Title: FS-HF200-V1.5	
Drawing No: zouxiaochuan	Version: 1.5
Drawn By:	Date: 2019-03-15
Checked By:	Date:
Approved By:	Date:
Size A3	Sheet: 1/3

修改记录

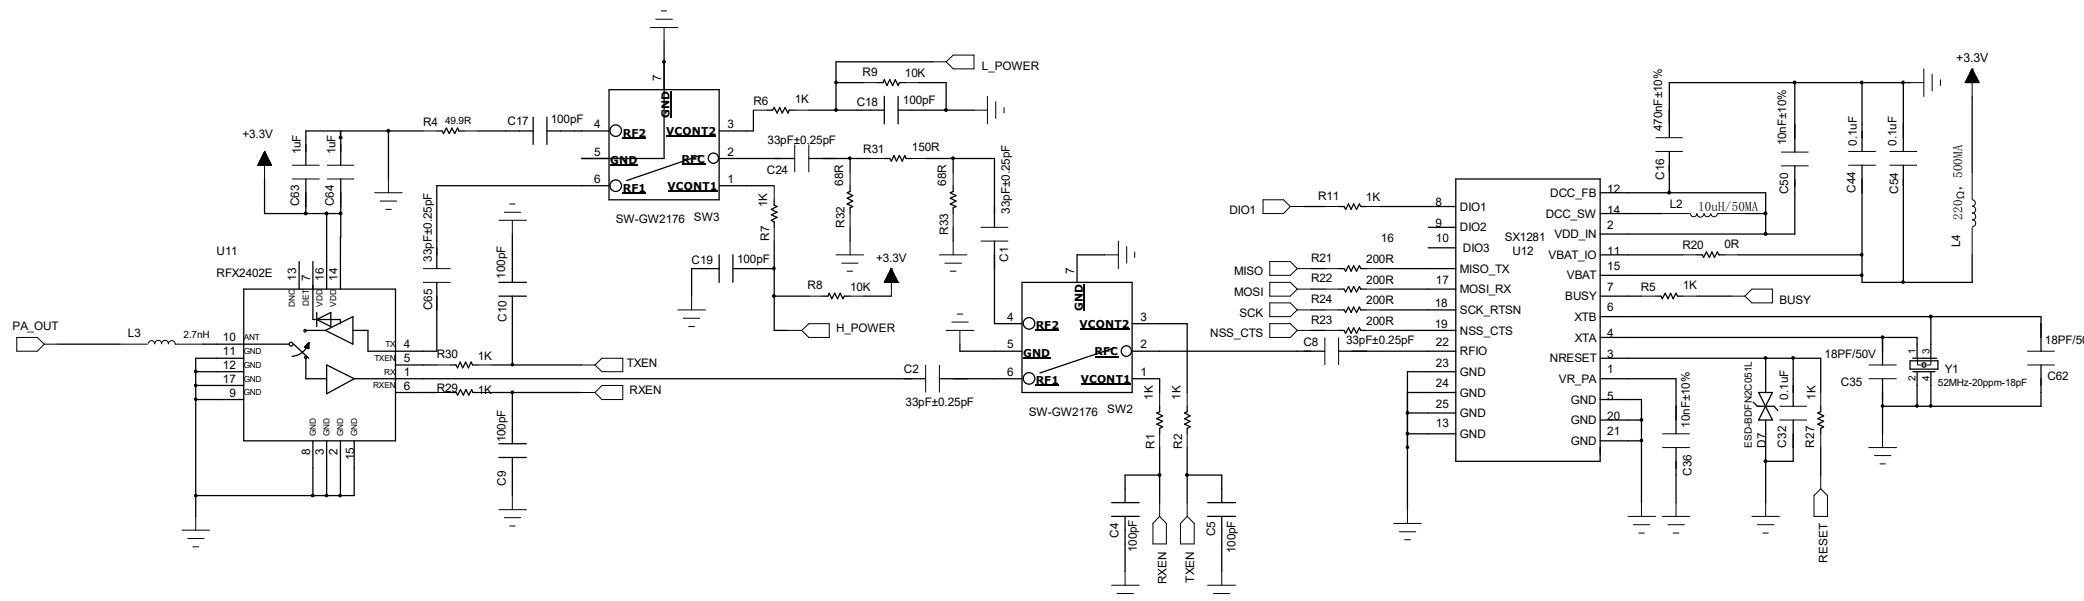
V1.1

1 增加开关

V1.2

1 增加电源部分，IC为2106

V1.3

1 变更电源的IC，改为1461

V1.4

1增加ESD管和电容，抗8KV静电

2更新电源部分的电容C13 C20 C23的大小

3 用主板上给到的3.5V供电

V1.5

1、将1461电源更改为一个LDO
